### ADDENDUM NO. 1 TO THE SPECIFICATIONS, PROPOSAL AND CONTRACT DOCUMENTS

### NORTHSHORE UTILITY DISTRICT

### Contract 2021-04 165/81 Water Main Replacement ISSUED THIS DATE: MONDAY, NOVEMBER 15, 2021

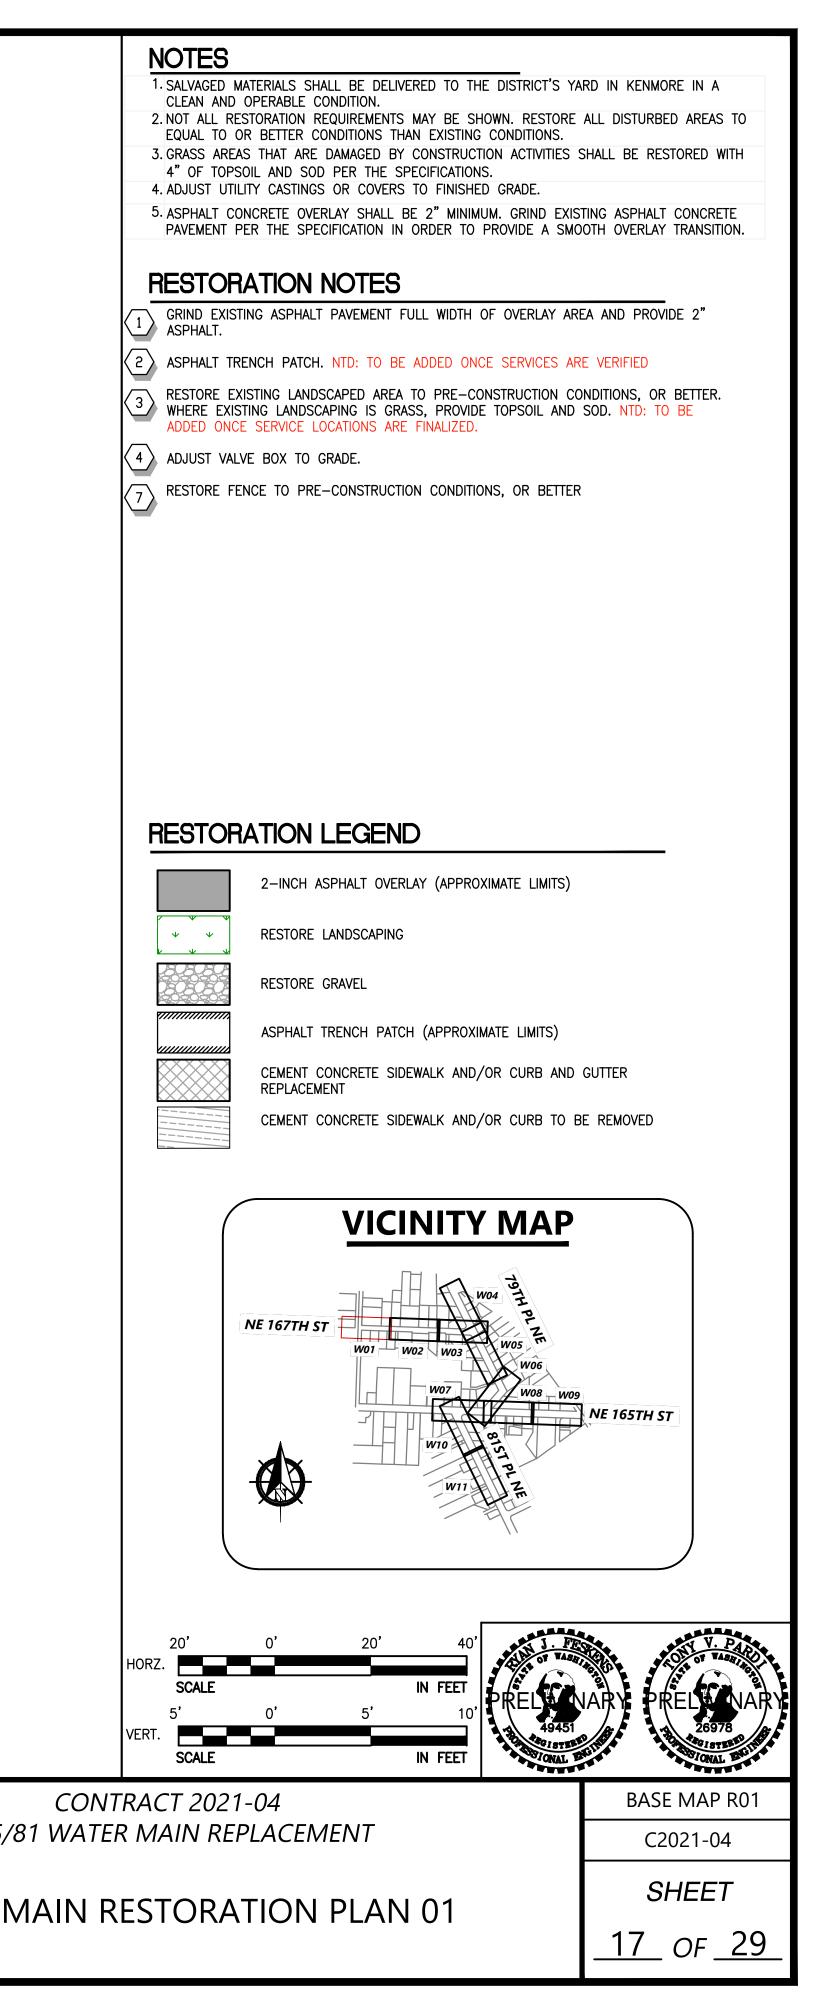
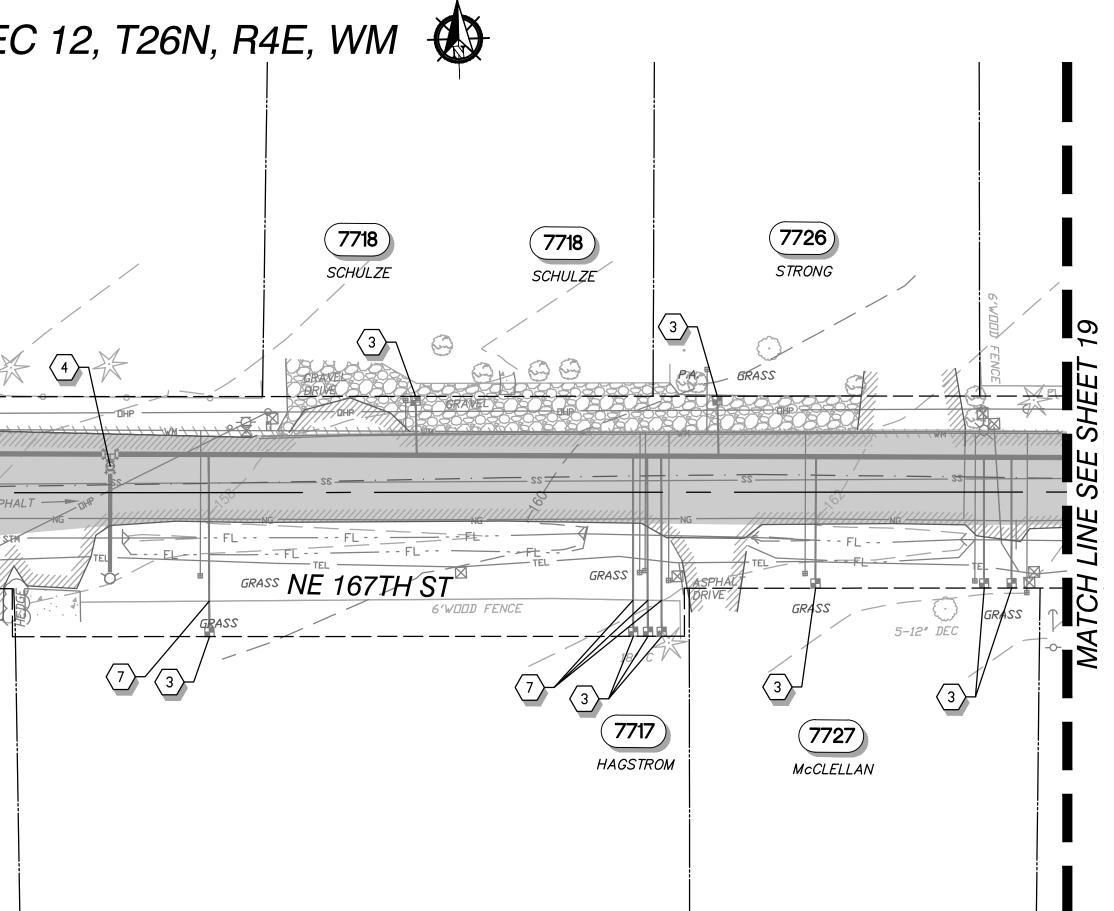
GRAVEL DRIVE 3 7625 TRACT 77			SE 1/4, S	SEC
			PUBLIC WORKS ENGINEERING APPROVED AS REDLINED SUBJECT TO ORDINANCE A				
NO	BY	APPD	REVISION	DATE	WARNING	DL17	DES DR
						RNZ	СНІ
					IF THIS BAR DOES NOT MEASURE 1" THEN DRAWING IS NOT TO SCALE		APP
				CTION	IS NOT TO SCALE		D

Overlays shall be per the City of Kenmore Road Standards 9.05. The existing striping and pavement markers shall be restored immediately following the overlay. If permanent striping cannot be installed, temporary striping shall be provided until permanent striping can be installed.

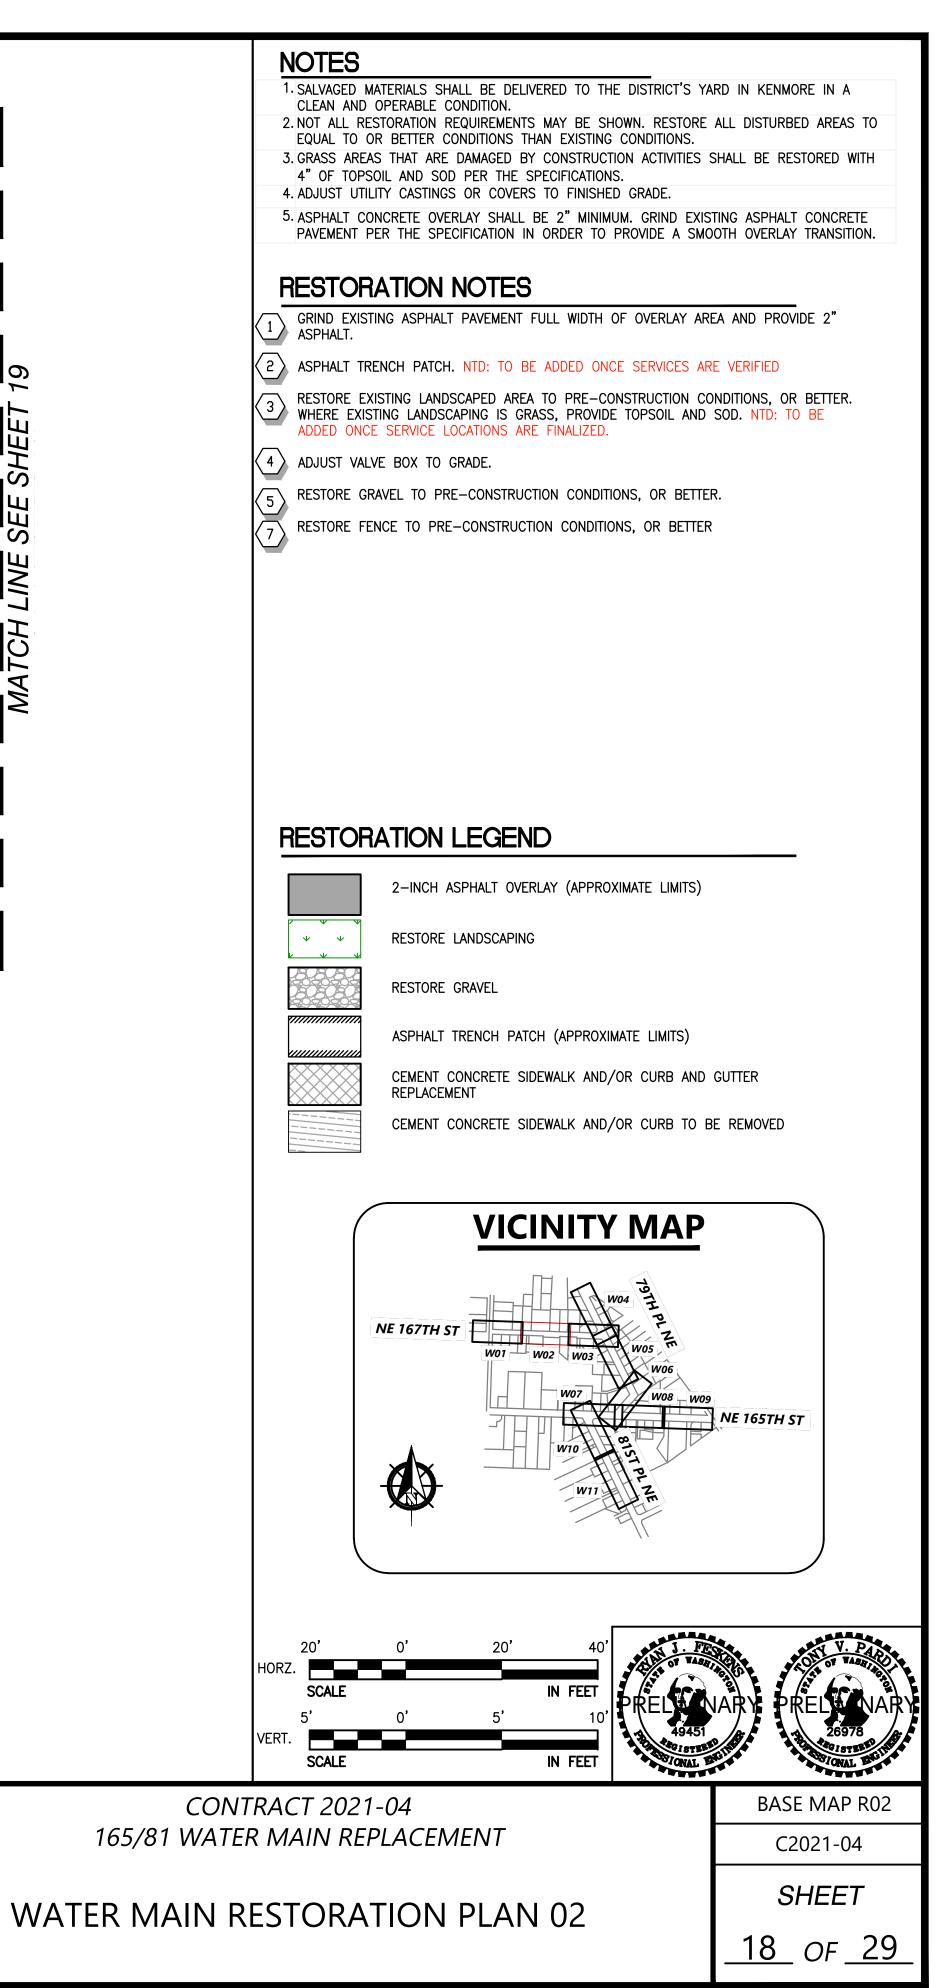
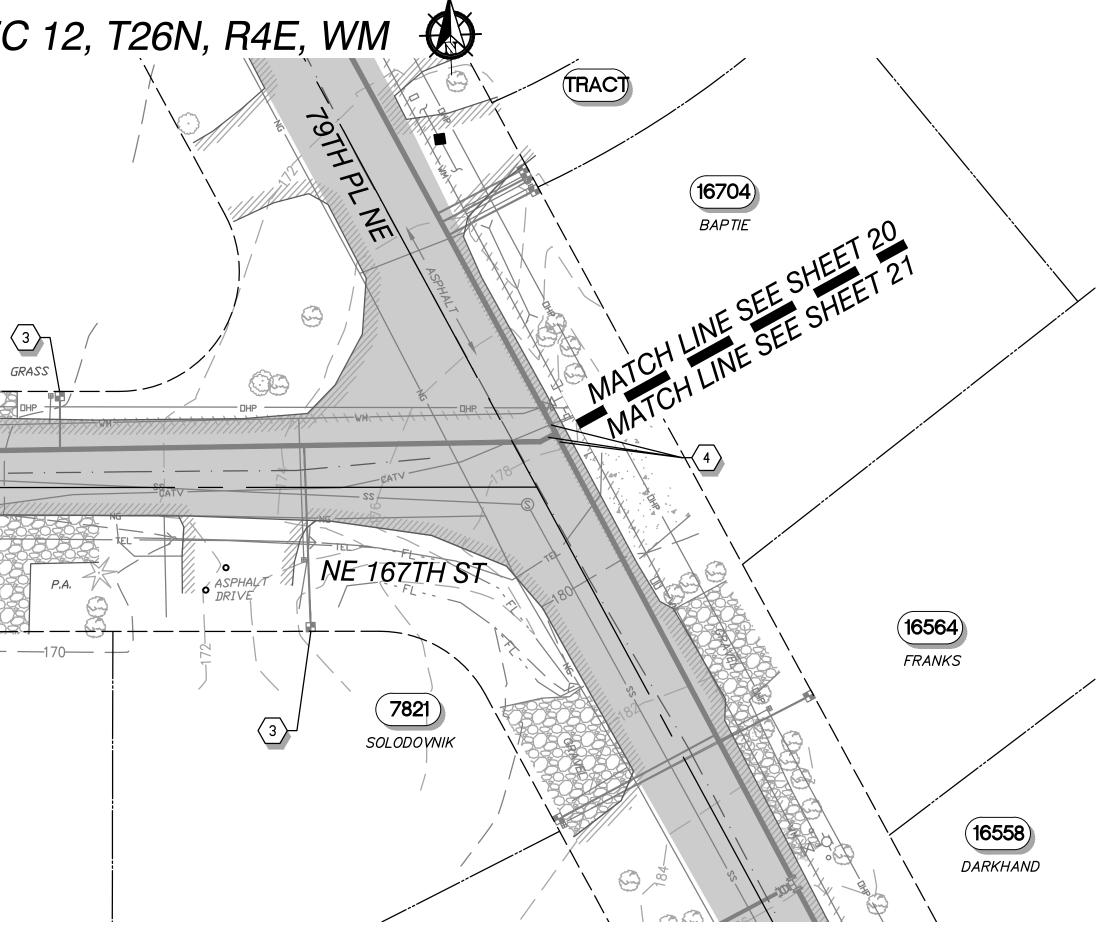
TROM BITTO CONTRACTOR BITTO CONTRACTOR B	$\sqrt{3}$			/4, S	
	St pa im sti sh	anda aveme nmedi riping	s shall be per the City of Kenmore Road ds 9.05. The existing striping and ent markers shall be restored ately following the overlay. If permanent cannot be installed, temporary striping provided until permanent striping can lled.			P	0	C W AP AS BJEC function
NO			REVISION	DATE	WARNING U V V V V V V V V V V V V V V V V V V	R	2	DESIG B DRA B CHEG B APPR DA

WATER MAIN RESTORATION PLAN 05

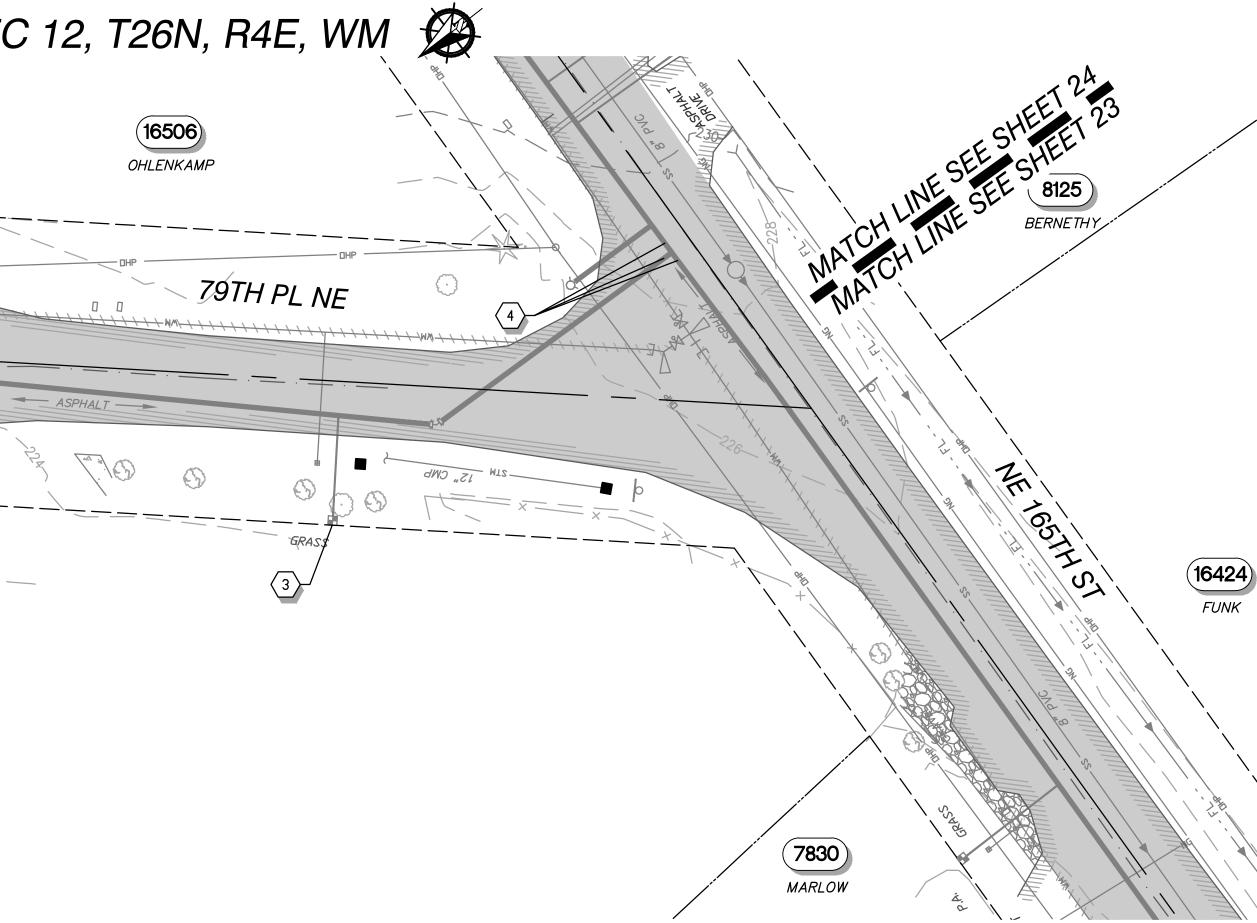
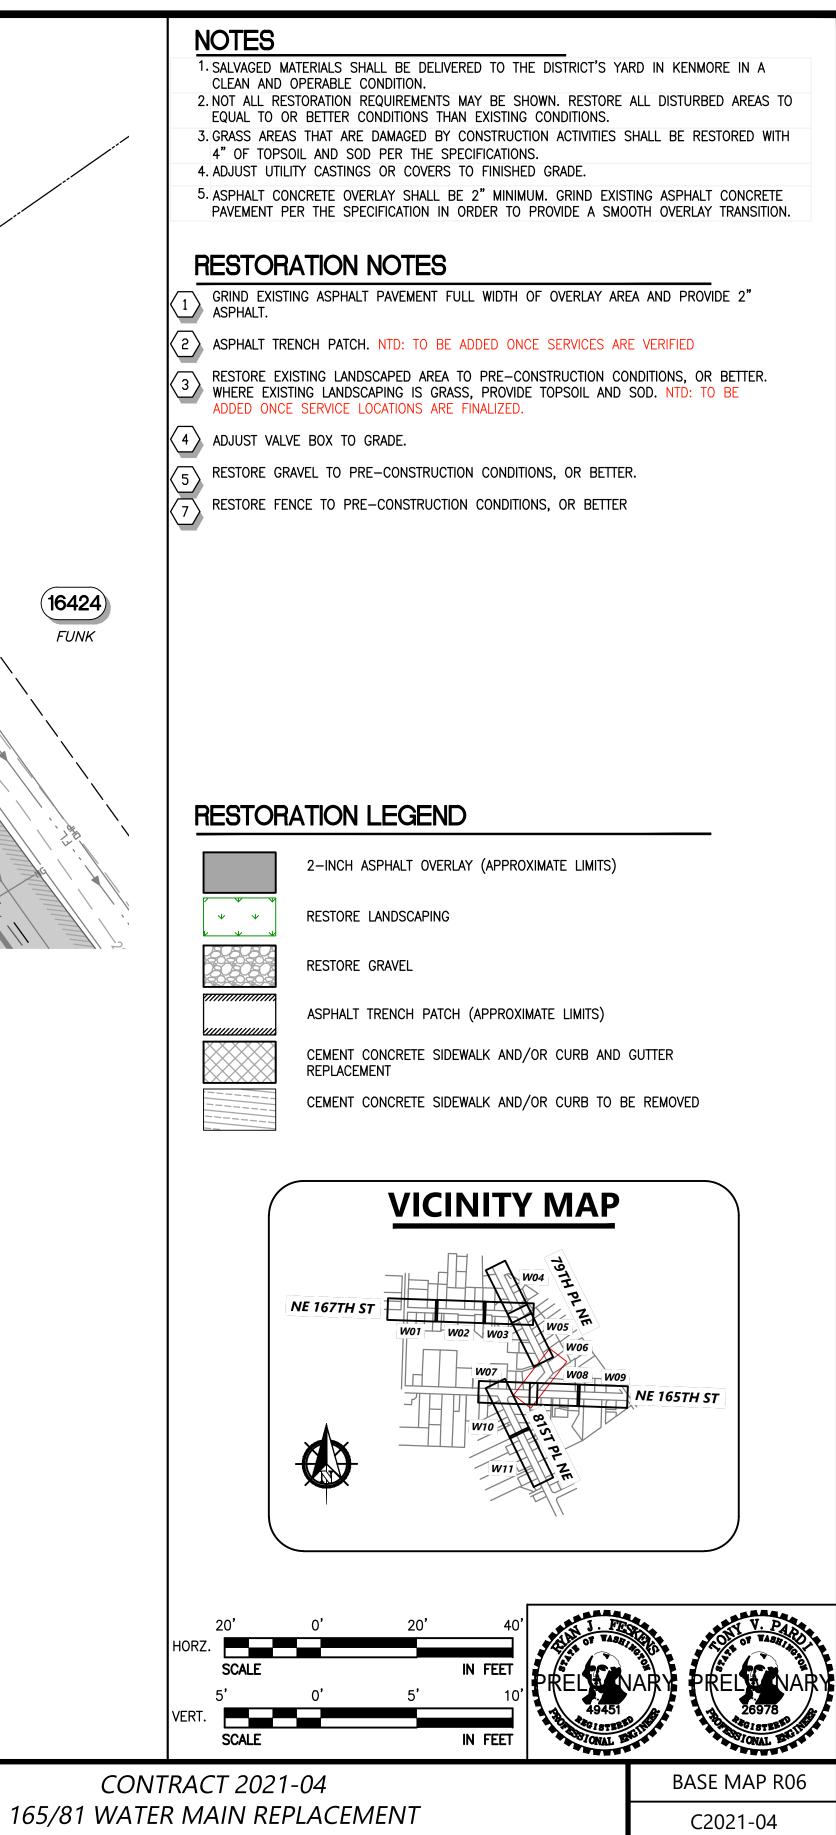
5 (3) (7) (6520) (7) (7) (7) (7) (7) (7) (7) (7) (7) (7		SE 1/4, SEC
			Marchines See She	_	1 1 1 1 1 1 1 1 1 1 1 1 1 1
			Overlays shall be per the City of Kenmore Road Standards 9.05. The existing striping and pavement markers shall be restored immediately following the overlay. If permanent striping cannot be installed, temporary striping shall be provided until permanent striping can be installed.		PUBLIC WORKS EN APPRO AS REDLI SUBJECT TO OR A CITY OF KE
NO	ВҮ	APPD	REVISION	DATE	WARNING DIA DESIG
					IF THIS BAR DOES NOT MEASURE 1" THEN DRAWING
Р	I PRELIN	l /INAR	Y DRAWING - 60% SUBMITTAL NOT FOR CONSTRUC	TION	THEN DRAWING IS NOT TO SCALE

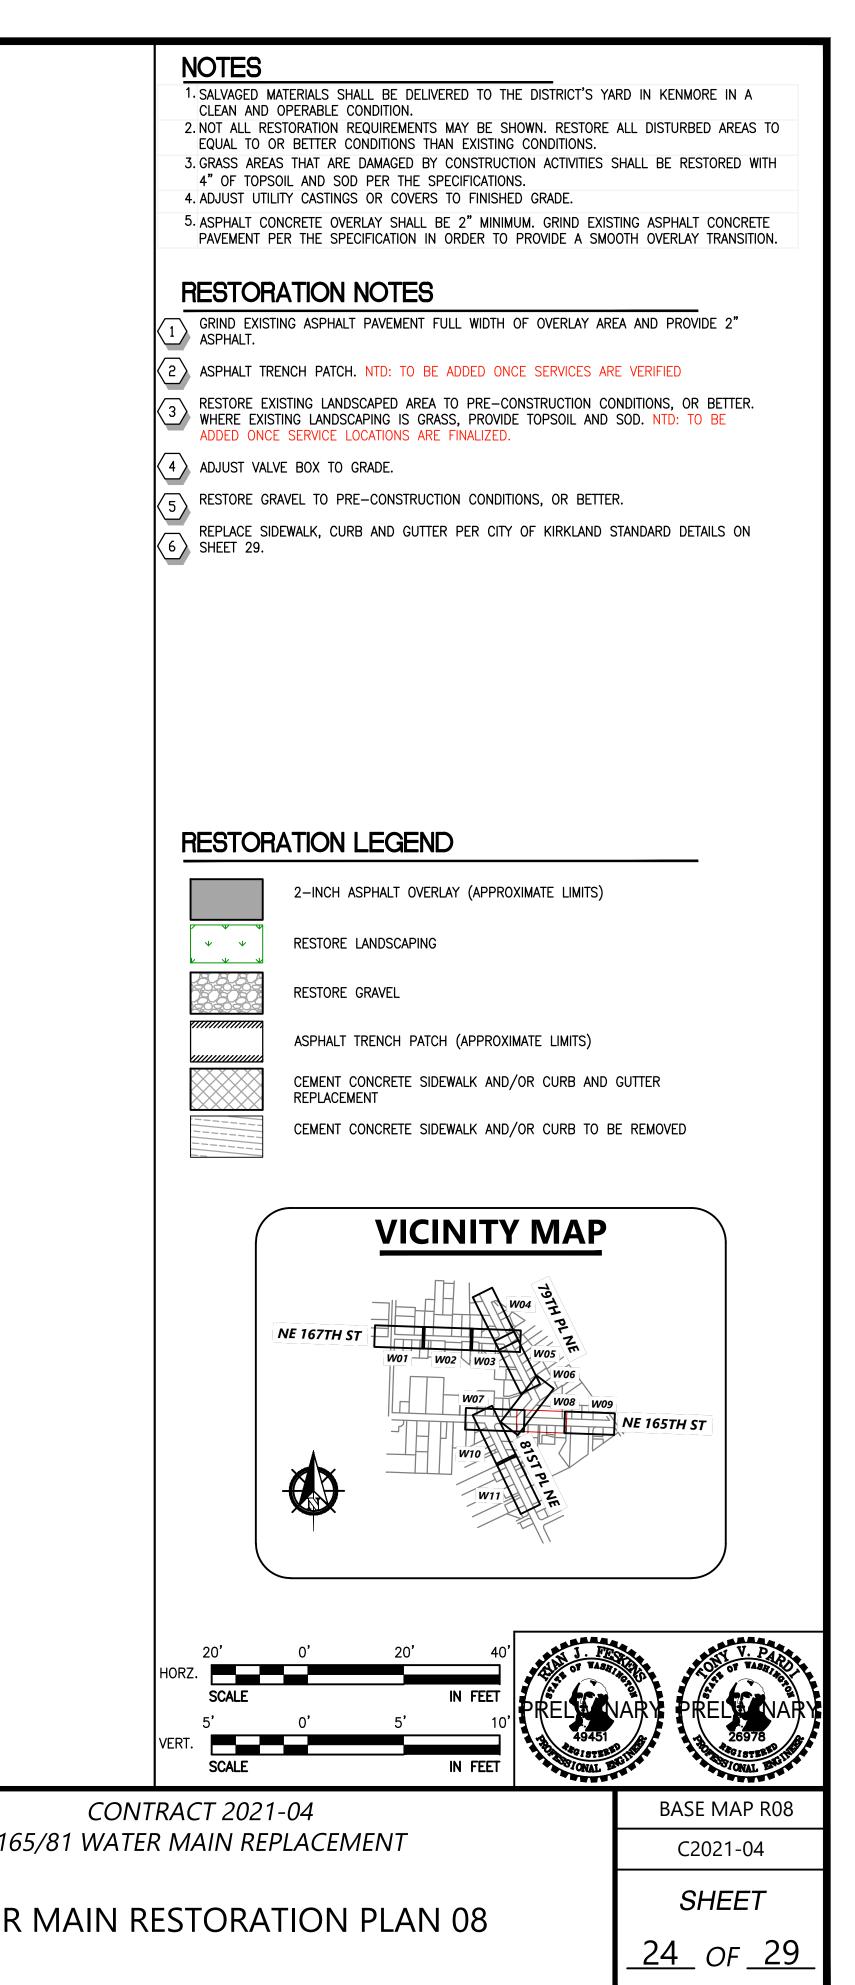
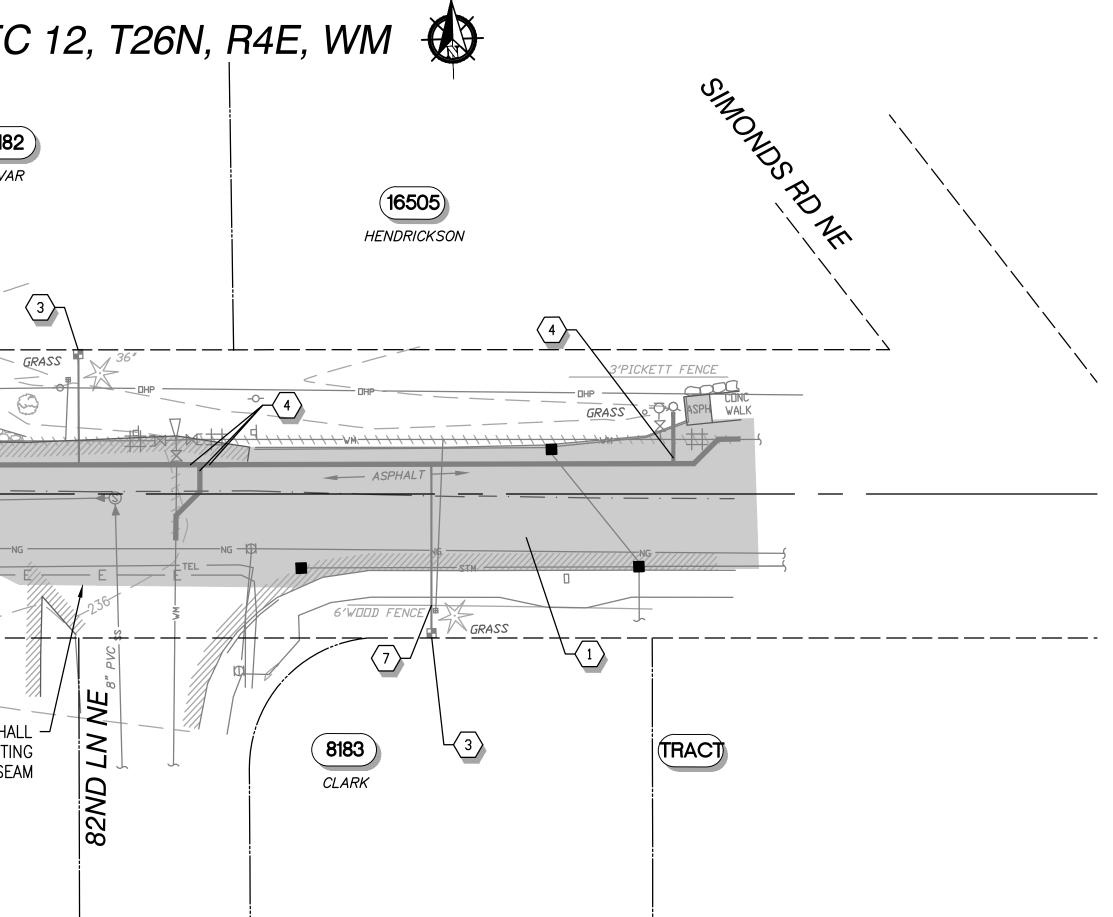
SE 1/4,	SE
	PUB	SUB	BIG3 WORKS ENGINEERI BIG3 WONG WORKS ENGINEERI PPROVED AS REDLINED JECT TO ORDINANCE	A'WEED RAIL FENCE		8175 LIN Over Stan pave imme strip	232 234 234 CHINE CONTRICTION	818 CVA
ΝΟ	ВҮ	APPD	REVISION		DATE		nstalled.	DES
						• WARNING • ½ 1	RH2	DES
					-	IF THIS BAR DOES		СНЕ
						NOT MEASURE 1" THEN DRAWING IS NOT TO SCALE		APPI
P	RELIN	/INAR	Y DRAWING - 60% SUBMITTA	L NOT FOR CONSTRU	CTION			D

ty of Kenmore Road g striping and restored verlay. If permanent temporary striping anent striping can
